121 Sheridan St.

Sheridan Heights

PLANNING REPORT #12-06

**ZONE CHANGE REQUEST
FROM R-6 RESIDENTIAL TO R-7 COMPACT URBAN RESIDENTIAL OVERLAY ZONE
VICINITY OF 121 & 135 SHERIDAN STREET
SHERIDAN STREET, LLC, APPLICANT**

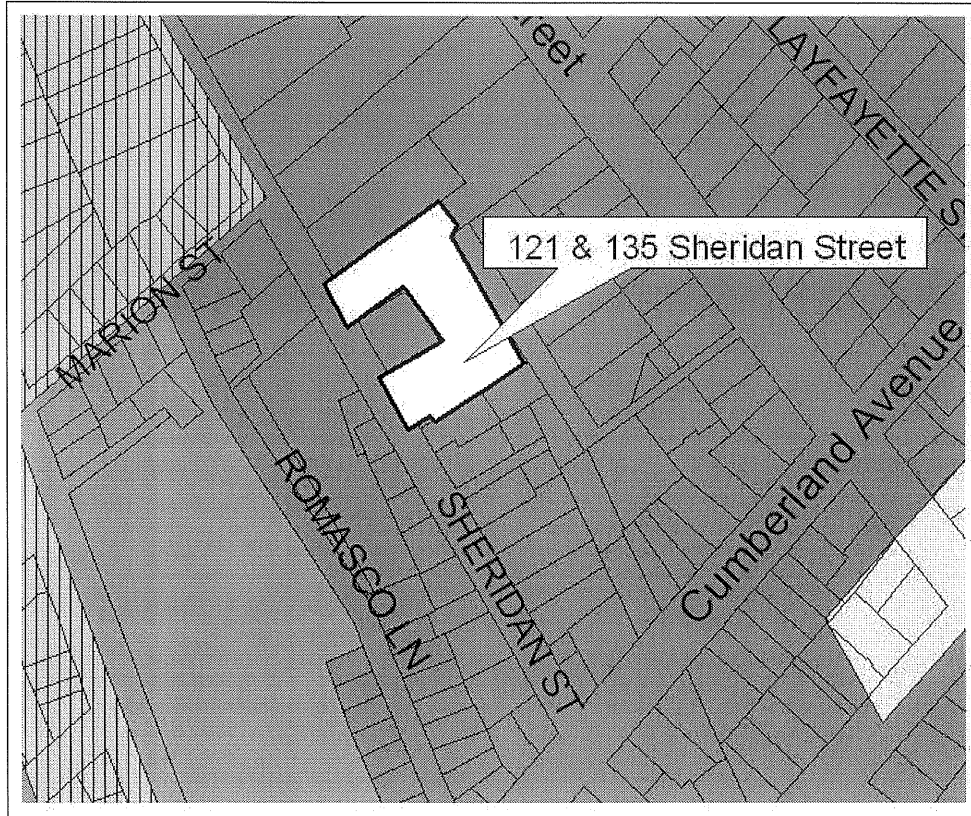
I have reviewed the traffic impact study prepared by Gorrill-Palmer Consulting Engineers, Inc. dated January 2006 and generally agree with their conclusions that the proposed project will not significantly impact traffic operations in the vicinity of the site. Specific comments are noted as follows.

- I would note that I do not approve of their trip generation adjustment, but the additional traffic would not change the conclusions.
- The study indicates that there are no safety deficient locations in the area. During the site plan permitting process, I will be requesting supporting documentation.

- In respect to the site plan, the applicant needs to provide justification for the reduced driveway width of 20 feet. The City standard is 24 feet.
- It appears that 17 parking spaces will be provided for the 21-unit building. It is very likely that this supply will be insufficient to accommodate parking demand on site.

- Sidewalks are not continuously provided on Sheridan Street between Cumberland Avenue and Walnut Street. There is a gap in sidewalk just north of the site. Eric Labelle should provide an opinion about the need to implement sidewalk in this area.
